BIOSWALE SECTION

OPTIONAL ROCK CHECKDAM

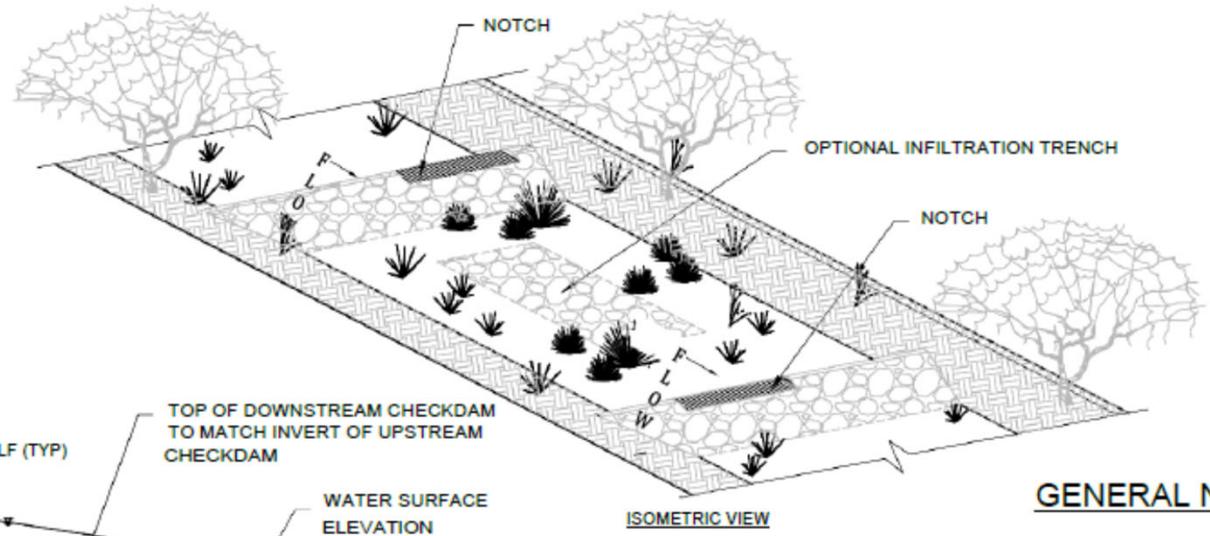
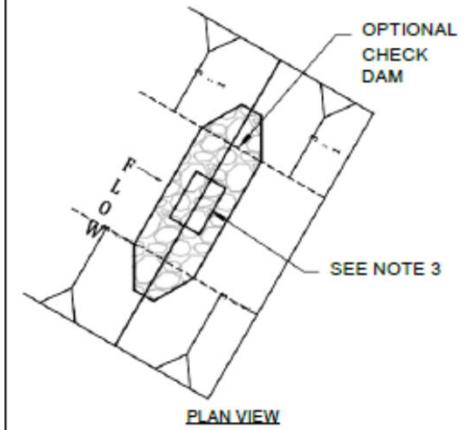
Suggest the following:

5 FEET MINIMUM OR AS SHOWN IN THE PROJECT PLANS

A MINIMUM OF 5 FEET

IN ACCORDANCE WITH

Make as a separate note

SHALL

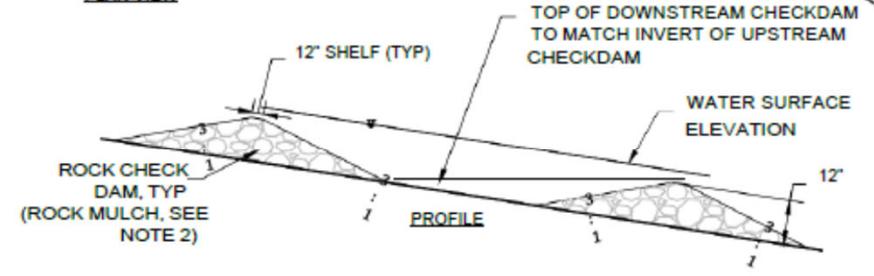
1. OPTIONAL CHECK DAM IS MEANT TO DISPERSE DURING HIGHER FLOWS, SEE SECTION 640.3.3 OF SPECIFICATIONS.
2. D50 SIZE DETERMINED BY THE DESIGN REPORT.
3. NOTCHES SHALL BE OFFSET FROM ONE ANOTHER.
4. DEDICATED OUTFLOW REQUIRED FOR THIS FEATURE.
5. OPTIONAL ROCK CHECK DAM TO BE LOCATED TO REDUCE VELOCITIES PER DESIGN REPORT.
6. RIPRAP AND ROCK MULCH REQUIRED WHEN VELOCITIES EXCEED TABLE 6.2 OF THE FLOOD CONTROL DISTRICT OF MARICOPA COUNTY HYDRAULICS MANUAL.

1. ROCK CHECK DAM (IF INSTALLED) SHALL DISPERSE HIGH FLOWS AND BE INSTALLED IN ACCORDANCE WITH SECTION 640.3.3 AND THE PROJECT PLANS/SPECIFICATIONS.
2. RIPRAP SHALL BE IN ACCORDANCE WITH SECTION 644.
3. NOTCHES SHALL BE OFFSET FEET FROM ONE ANOTHER.
4. A DEDICATED OUTFLOW SHALL BE INSTALLED AS SHOWN ON THE PROJECT PLANS/SPECIFICATIONS.
